Model: Mojito	Date: 26-Apr-00	No.: MA293001a
---------------	-----------------	----------------

MB Correction

Modified Article: Parts Catalog Correction		Prepared by: A. Sasaki	
From: Technical Services Dept., GTS Division			
Reason for Modification:	☒ Parts catalog correction	☐ Vendor change	☐ To meet standards ()
	☐ To facilitate assembly	☐ To improve reliability	
	☐ Part standardization	☐ Other

15. Optics Section 2

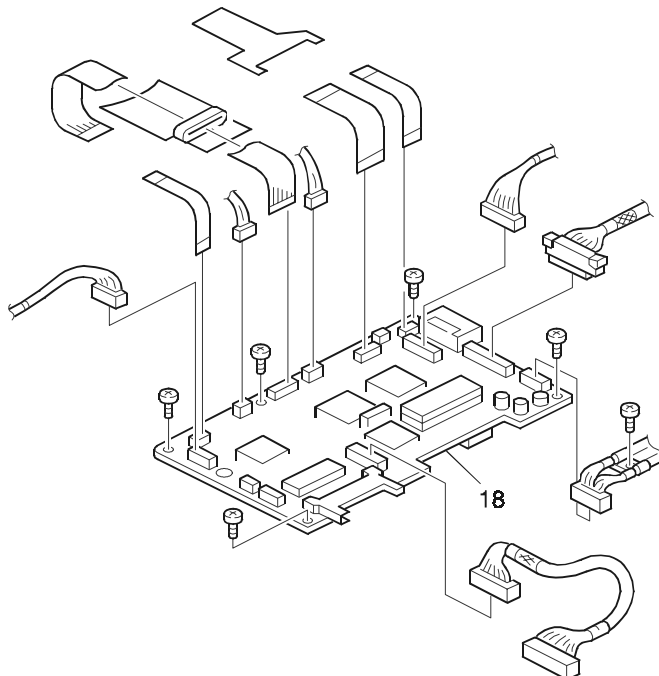
Please correct your parts catalog.
The BICU for Lanier is same as other versions.

Old part number	New part number	Description	Q'ty	Int	Page	Index	Note
A2935101		BICU Board (LAN)	1	X/O	43	18	
	→ A2937552	BICU Board (NA)			157	*	
	→ A2937562	BICU Board (EU)

58. Electrical Section 1

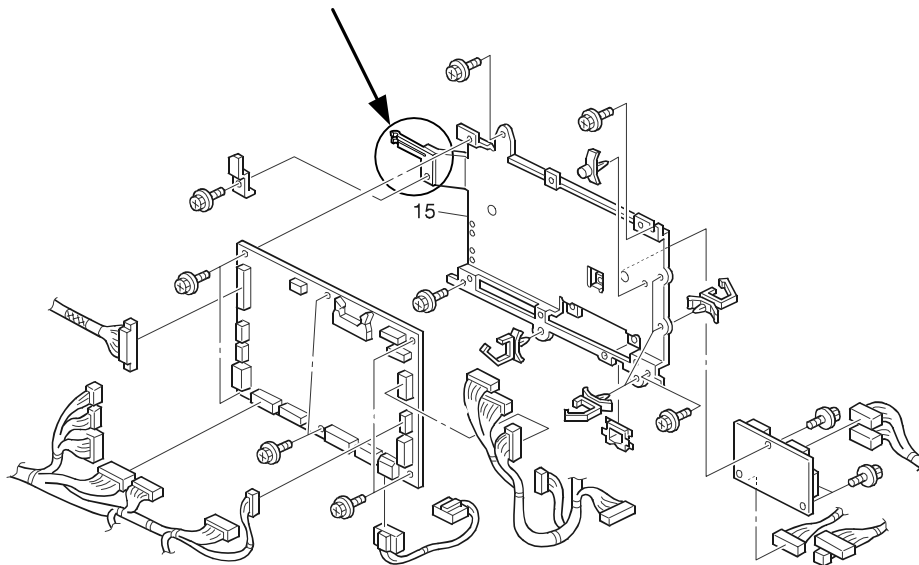
To ensure grounding, a grounding plate has been added to the I/O board bracket.

Old part number	New part number	Description	Q'ty	Int	Page	Index	Note
A2935850	A2935845	Bracket – I/O Board	15	X/O	129	15

48. Inverter & Duplex Unit 4

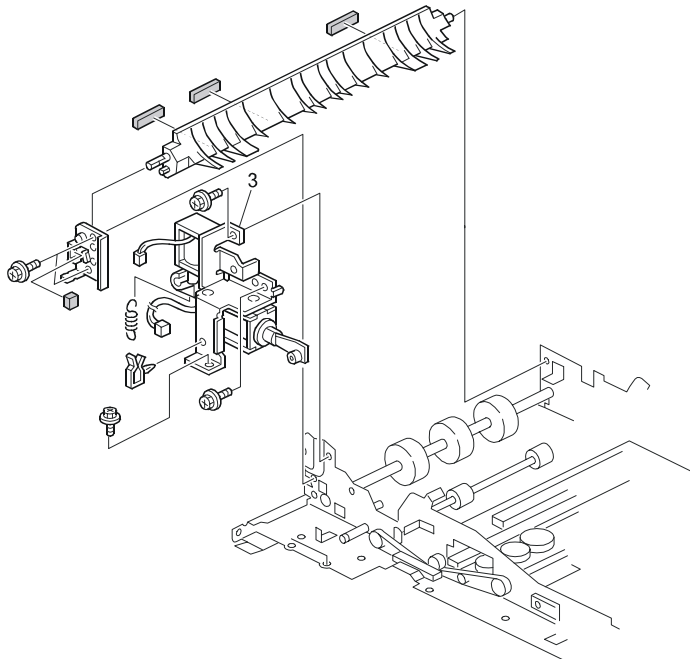
To prevent dog ears when using Legal paper, the DC solenoid bracket has been modified.

Old part number	New part number	Description	Q'ty	Int	Page	Index	Note
A2934781	A2934782	DC Solenoid Ass'y	1	X/O	109	3

49. Inverter & Duplex Unit 5

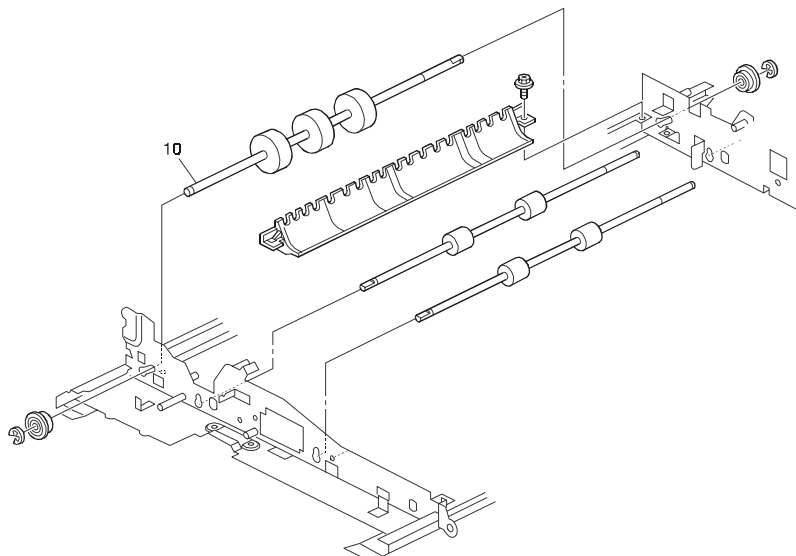
To prevent the edges of the paper from becoming dirty when making duplex copies, the material of the duplex roller has been changed.

Old part number	New part number	Description	Q'ty	Int	Page	Index	Note
AF020498	AF020533	Duplex Roller	1	X/O	111	10

42. Fusing Unit 1

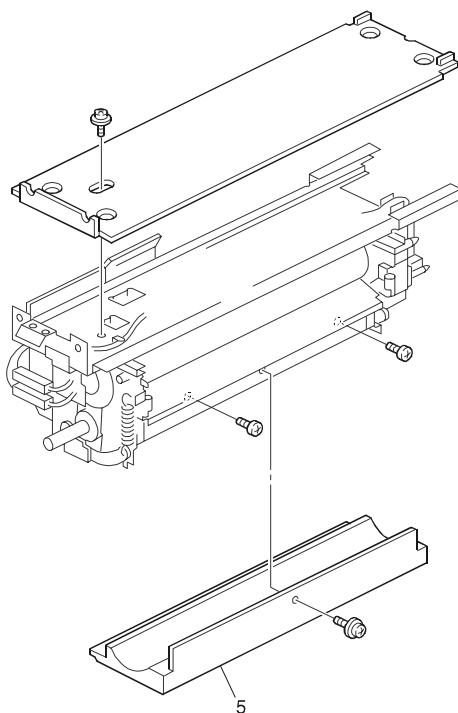
As per factory request, the lower fusing cover for the US model has been changed.

Old part number	New part number	Description	Q'ty	Int	Page	Index	Note
A2934161	A0964161	Lower Fusing Cover	1	O/O	97	5

41. Transport Section 2 (A292/A293)

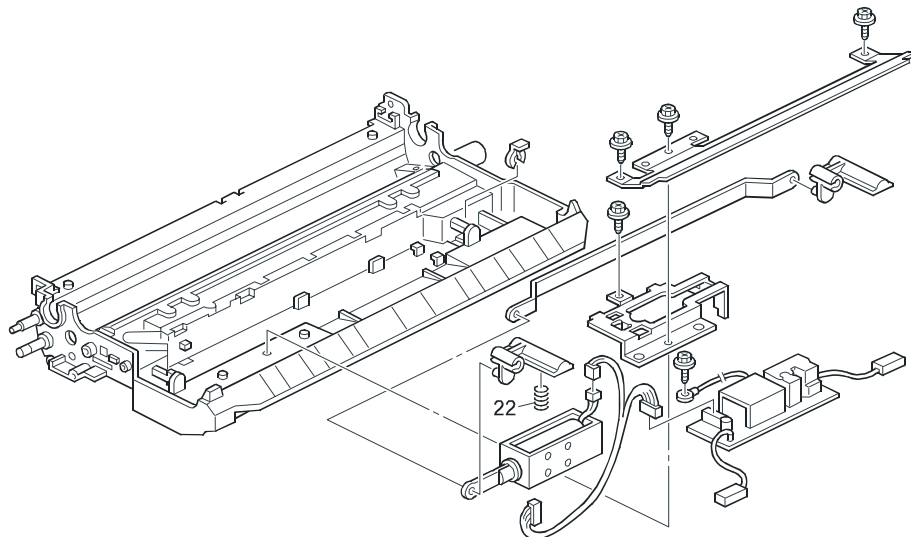
To ensure release of the transfer belt from the drum, the compression spring has been deleted.

Old part number	New part number	Description	Q'ty	Int	Page	Index	Note
AA063485		Compression Spring	1	-	95	22

14. Optics Section 1

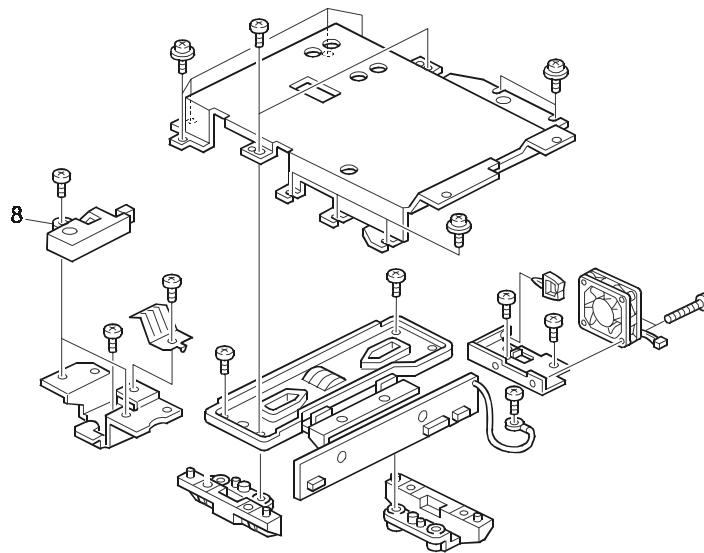
To ensure the operation of the original length sensor, a filter has been added to the original length sensor.

Old part number	New part number	Description	Q'ty	Int	Page	Index	Note
AW010078	A2941843	Photosensor with Filter – H50	2	X/O	41	8

32. Toner Bottle Holder

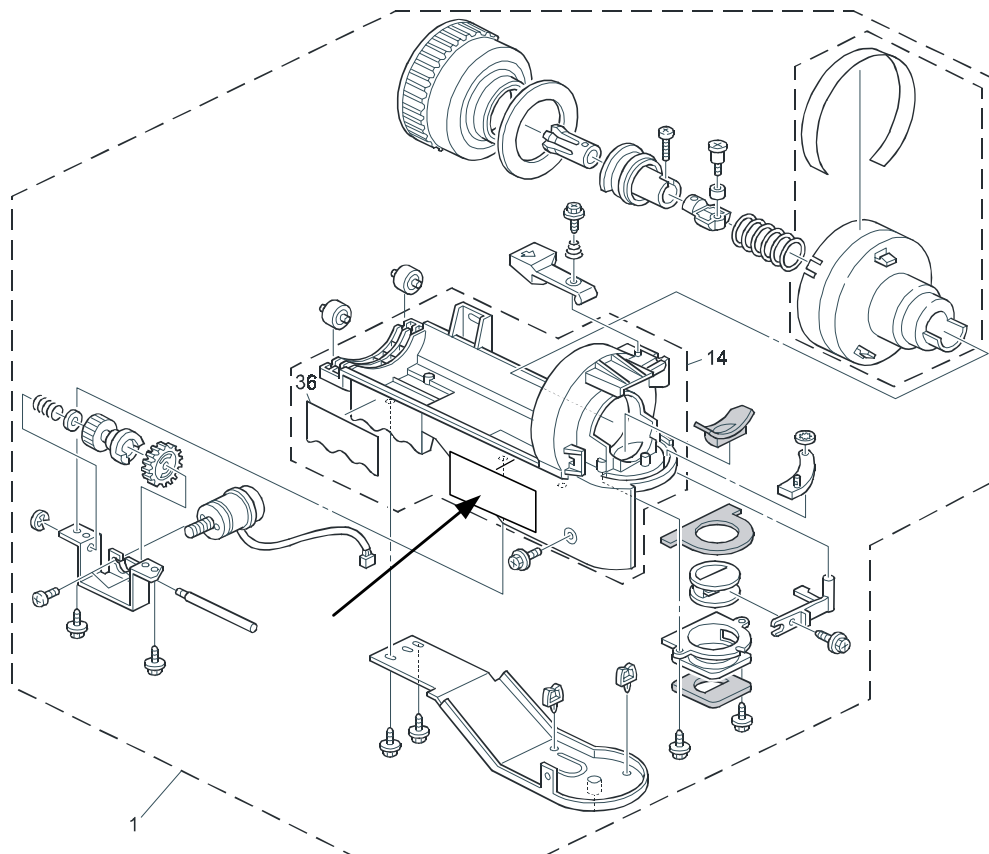
As per field request, a caution decal has been added to the bottle holder.

14. Optics Section 1

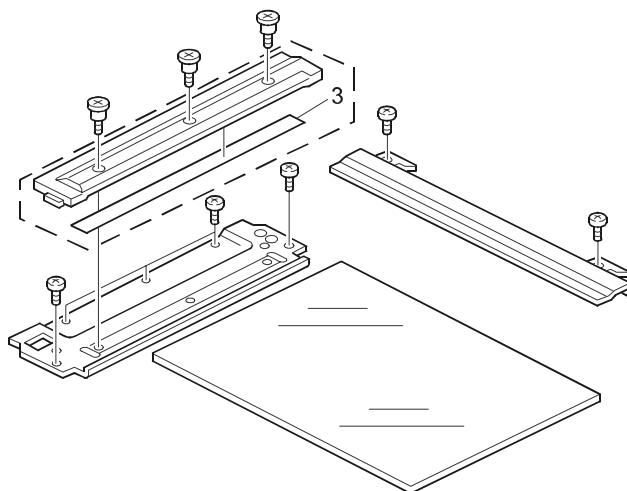
To ensure that the left scale fits the exposure glass correctly, the width of the left scale sheet has been changed from 15.5 mm to 14.5 mm.

Old part number	New part number	Description	Q'ty	Int	Page	Index	Note
A1931752	A2931793	Left Scale Guide Left Scale Sheet	1	X/O	41	3

25. Paper Feed Section 1

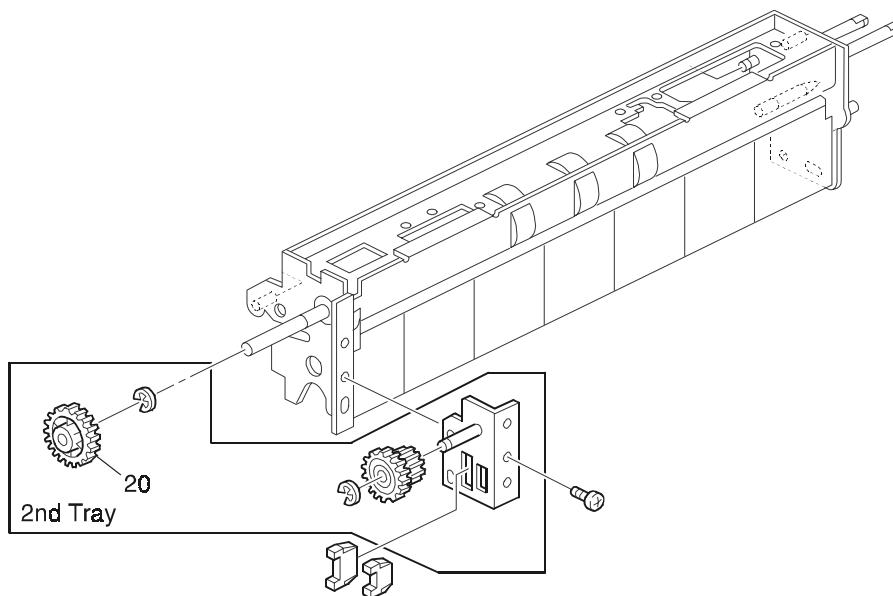
To improve reliability, the gear with a one-way clutch has been changed.

63. Frame Section 2

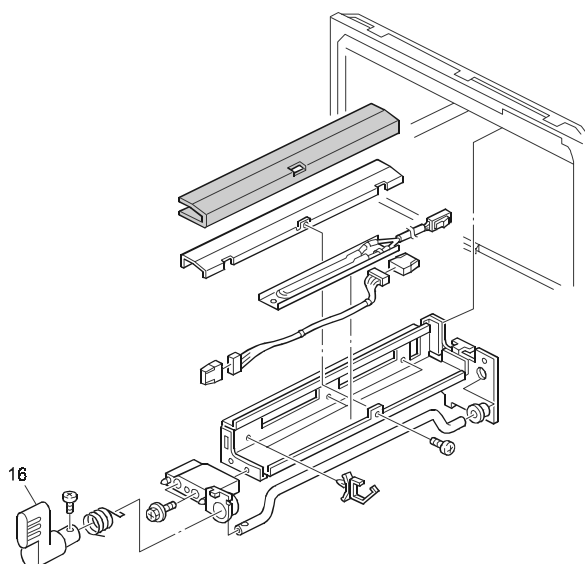
To improve ease of operation, a cover has been added to the belt unit knob.

18. LASER UNIT (A292/A293)

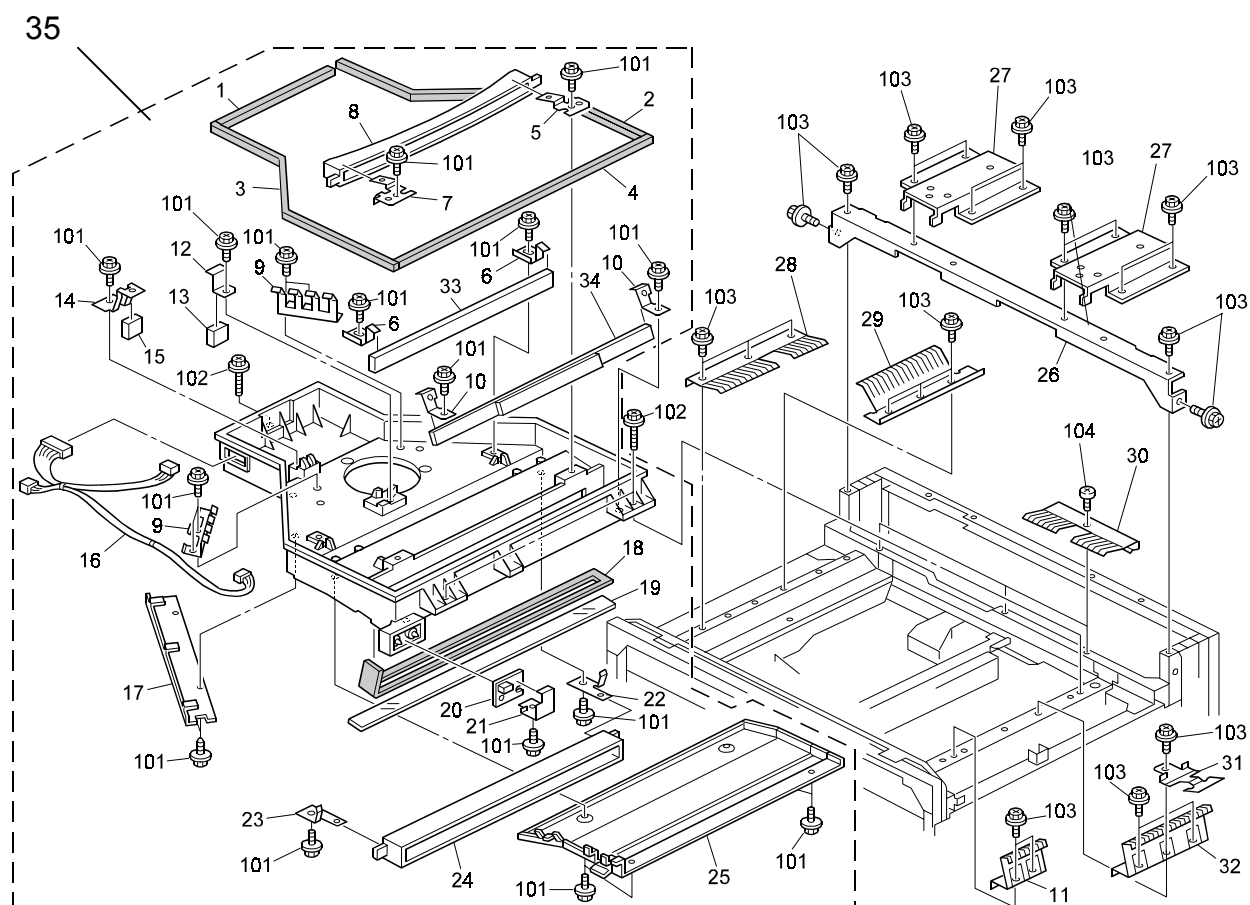
As per field request, the parts encircled by a dotted line in the illustration below has been registered as an assembled service part.

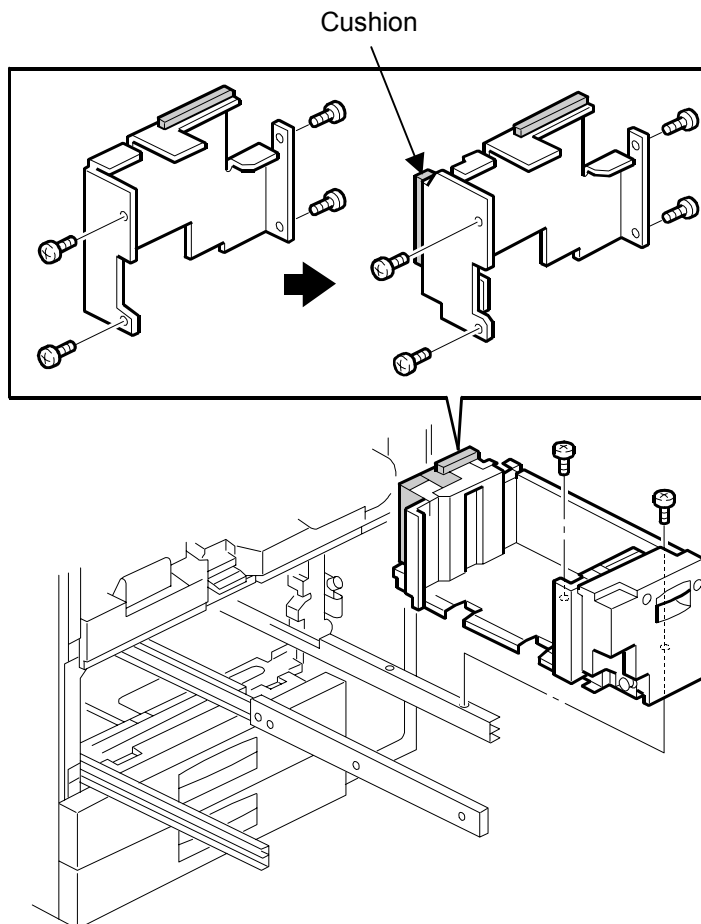
The Right Rear Inner Cover has been strengthened and a cushion has been added, in order to ensure that the following does not occur even when the Tandem Tray is closed forcefully or the paper is mis-loaded:

The side fences reopen, which prevents the Right Tray from lifting up or sometimes causing damage to the Left Tray Back Fence (see RTB #RA293020 for details).

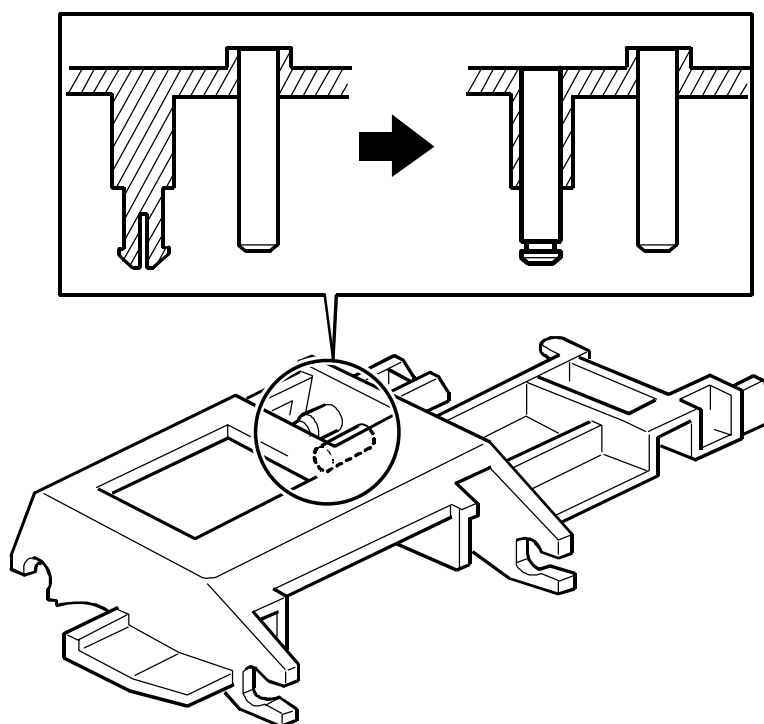
The pick-up roller bracket has been changed for parts standardization with a new model. As shown below, the new bracket contains a metallic shaft for the timing pulley (A8062151) to improve the bracket's durability.

Old part number	New part number	Description	Q'ty	Int	Page	Index	Note
A8061314	B3011314	Pick-up Roller Bracket	1	X/O	25	17

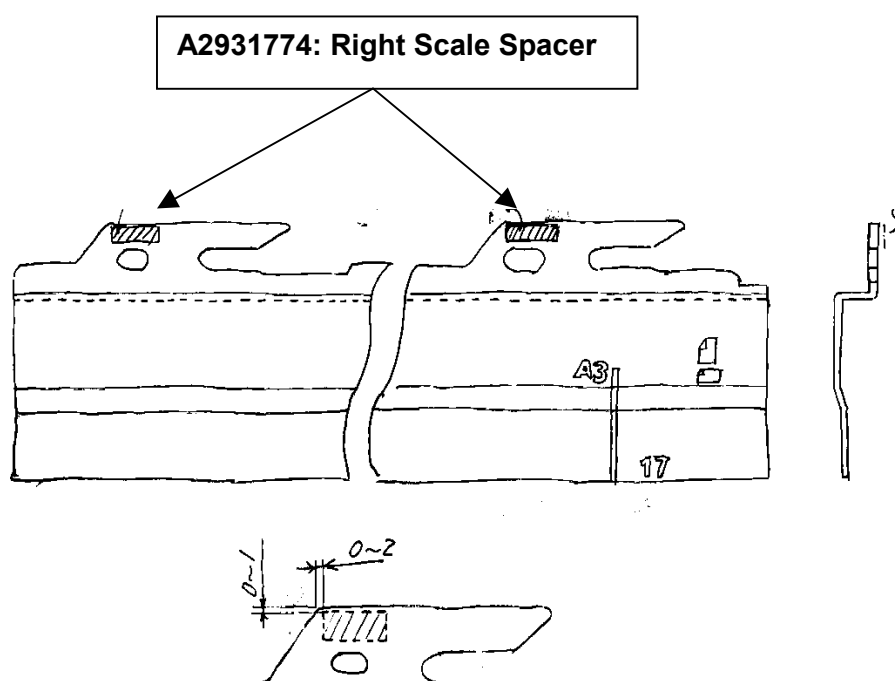
To facilitate assembly, two right scale spacers have been attached to the right scale as shown below.

Note: These spacers attach behind the right scale.

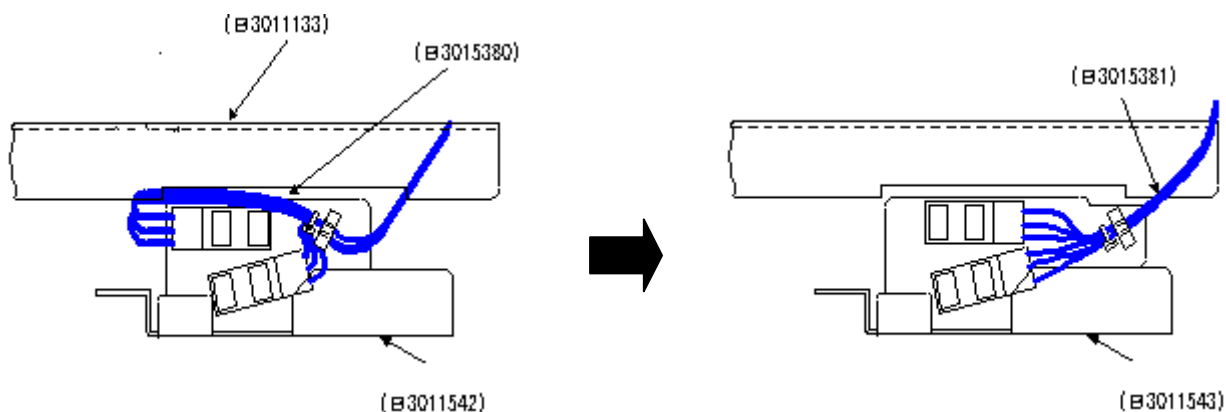
To prevent contact with the Right Stay (B3011133), ***the routing of the DF Position Sensor Harness has been changed as shown below. In addition, the length of the harness has been increased.***

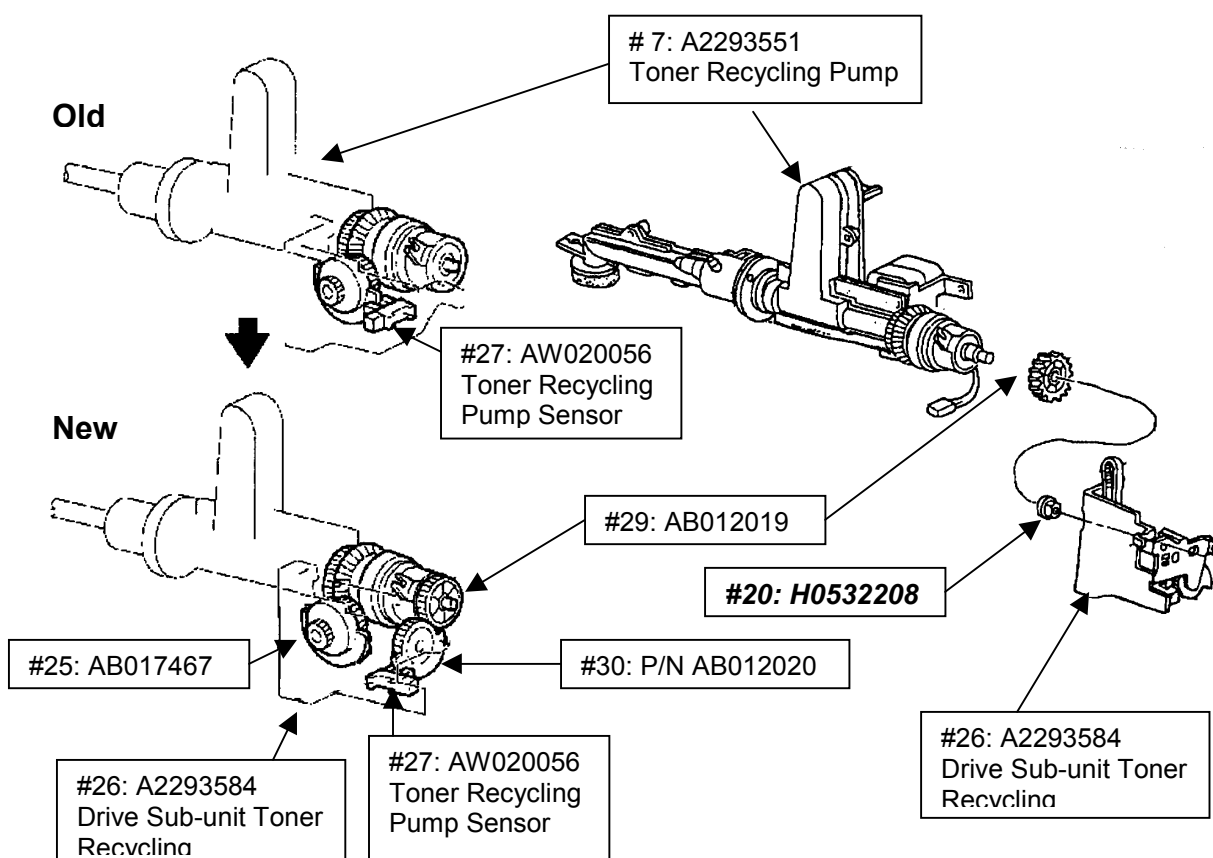
To improve the detection of the toner pump lock, the Toner Recycling unit has been changed as follows:

1. Changed the position of the Toner Recycling Pump Motor Sensor on the Bracket - Toner Recycling Drive.

2. Added two gears (index #29, 30 below).

Old part number	New part number	Description	Q'ty	Page	Index	Note
	AB012019	Gear – 25Z	1	123	29	
	AB012020	Gear – 28Z	1	123	30

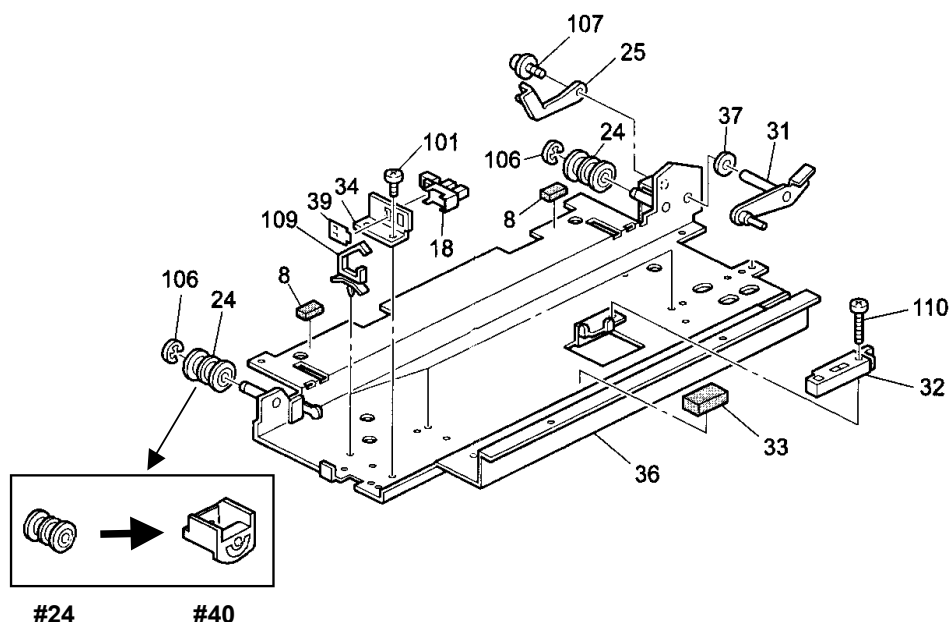
To ensure that the rollers re-engage the rail when the tray is pushed back in (even if they derail), 1 of the 2 Slide Rail Rollers has been deleted, and a Side Rail Front Roller has been newly added.

Old part number	New part number	Description	Q'ty	Int	Page	Index	Note
AF022105	AF022105	Roller – Slide Rail	2 - 1	-	57	24	-
	A2946655	Roller – Slide Rail Front	0 - 1	-	57	*40	-
